Template for comments and secretariat observations:

Date: 2016_03_08	Document: ISO/FDIS 7637- 3	Project:
------------------	----------------------------	----------

ISO/TC22/SC32/WG3 N 2571

Figure 2 – Test set-up for CCC method – DUT Test

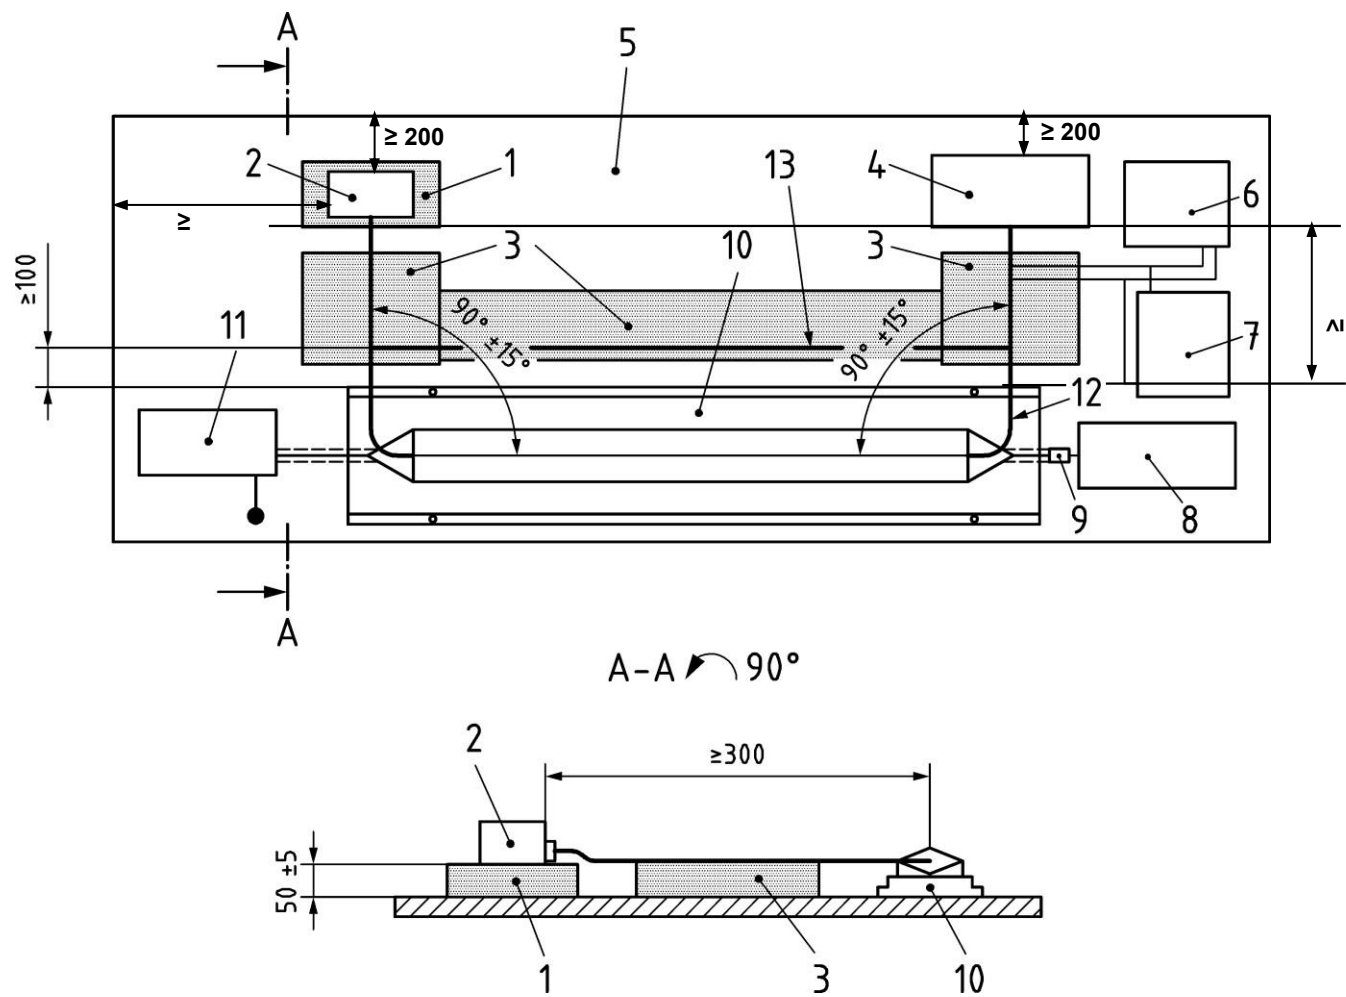
US 6	4.5.3	2 nd paragraph	ed	Use of the phrase "...50 Ω attenuator which is mounted to coupling clamp as shown in Figure 1." is not clear of intent to connect the attenuator to the CCC directly (i.e. no cables)	Propose word change to: "...50 Ω attenuator which is directly connected to the output of the CCC (no intermediate cable connections) as shown in Figure 1."	
US 7	4.5.4	1 st paragraph	ed	The text: "the test method using the CCC is shown in Figure 2" should be modified because it is talking about the setup not the overall method, which includes test procedures.	Replace text with: "The test setup using the CCC is shown in Figure 2"	
Fr2	4.5.4	2 nd paragraph	ed	ISO 7637-3 concerns coupling via lines other than supply lines and therefore DUT 12 / 24 V supply lines shall not be included in the CCC.	Replace: "The DUT 12/24 V supply lines (ground and supply) should not be included in the CCC." By : "The DUT 12/24 V supply lines (ground and supply) shall not be included in the CCC."

Figure 3b – Set-up for fast transient pulses level adjustment – DCC method

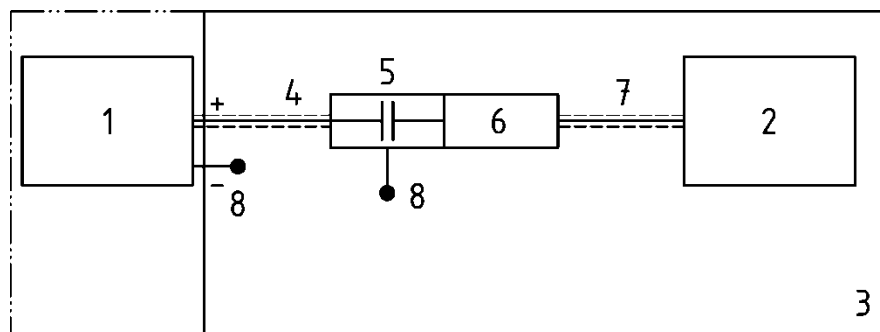
Fr5	4.6.3	Figure 3b	ed	The used of a 1 kΩ to 50 Ω adapter is recommended and not mandatory.	Key 6 : Replace: " 1 kΩ to 50 Ω adapter" by "1 kΩ to 50 Ω adapter (if used) "	
US 13	4.6.3	1 st bullet point under paragraph 1	ed	Text states that "The transient pulse level shall be measure using a high impedance passive probe." No parameters are provided regarding the characteristics of this probe. Text should reference ISO 7637-2.	Proposed text change: "The transient pulse level shall be measure using a high impedance passive probe whose characteristics conform with that delineated in ISO 7637-2"	
US 14	4.6.3	Figure 3a	ed	Figure key lists passive probe. Should also include reference to ISO 7637-2	Proposed text change: "6. high impedance passive probe (see ISO 7637-2)"	
Fr6	4.6.4	4 th and 5 th paragraph	ed	These two sentences are not exactly the same than those in paragraph 4.4 (3 and 4th paragraph) which concerns general test setup conditions for DUT insulation and grounding.	Deleted the two paragraphs.

Figure 4a – Test set-up for DCC method – Slow transients – DUT Test

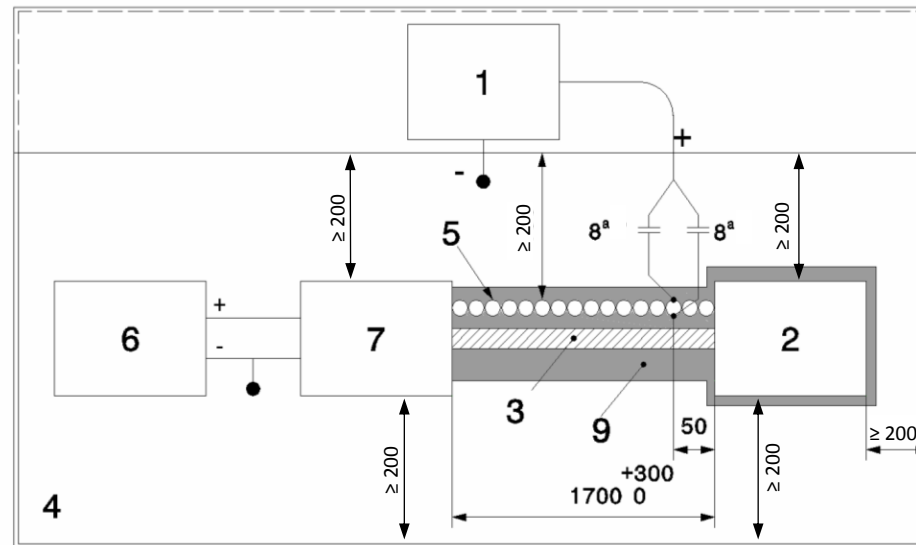
Fr7	4.6.4	Figures 4a, 4b, 5a, 5b	ed	The 50 mm distance should be a maximum distance.	Modify Figures 4a, 4b, 5a, 5b by replacing "50" by " ≤ 50 " for the distance between the DUT and the capacitor connection.	
Fr8	4.6.4	Figures 4b, 5b	te	The distance between metallic box (8) and DUT I/O line (5) may influence the test result.	Modify Figures 4b, 5b by replacing " ≤ 50 " by : " (50 ± 5) ".	
Fr9	4.6.4	Last paragraph	ed	Figures 5a and 5b are examples when figures 4a and 4b aren't. Therefore, it is preferable to have the distance requirements stated in the wording.	Add after last paragraph of 4.6.4 : "The distance between the I/O line injection point and the DUT shall be lower or equal to 50 mm. For fast transient, the distance between the I/O line injection point and the capacitor shielded box shall be (50 ± 5) mm". Delete "Example of" in the title of Figures 5a and 5b.	
Fr10	4.6.4	Figures 4a, 4b, 5a, 5b and paragraph 4.6.4	ed	There is no consistency between the 4 Figures for the distance between I/O line and edge of the ground plane (no requirement in Figure 4a and 4b).	Modify Figures 5a and 5b by replacing "100" by " ≥ 100 " Add in Figures 4a and 4b an arrow with " ≥ 100 " Between I/O line and edge of the ground plane. Add at the end of 4.6.4: "The distance between the I/O line and the edge of the ground plane shall be greater or equal to 100 mm".
